## **Statement of Compliance Access for People with a Disability**

**Mixed use development at  
2 - 6 Bold Street & 80 - 82 Cowper Street,  
Granville**

**Report Type:** DA Access report  
**Development:** Mixed use development at 2 - 6 Bold Street & 80 - 82 Cowper Street, Granville

Typical Units    Adaptable Units Required  
Units 12 & 26    Adaptable Units Provided

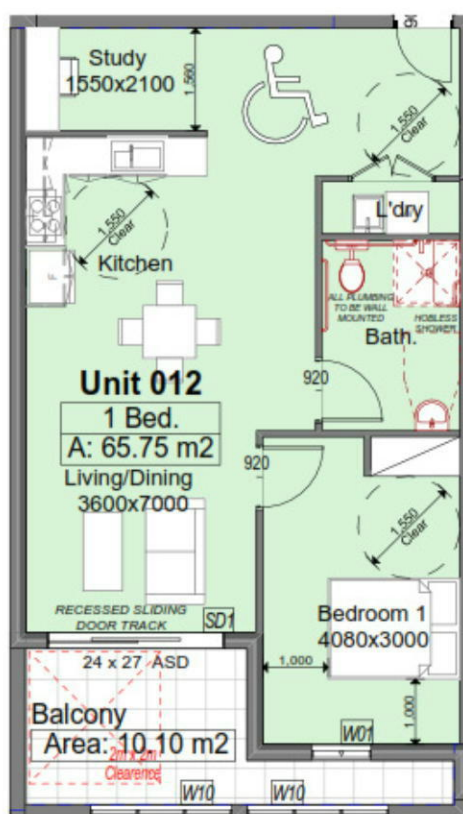
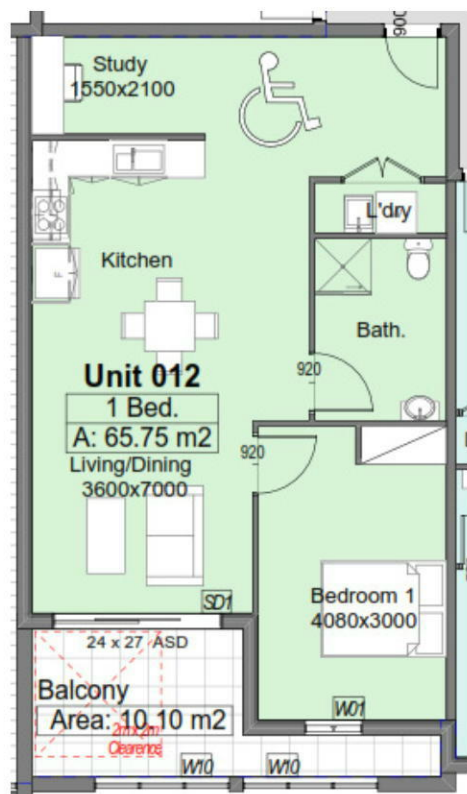
Note: The location of the WC pan and Shower is required to be the same in both, pre and post adaptation drawings. This is easily achievable and can be provided at the CC stage of works.
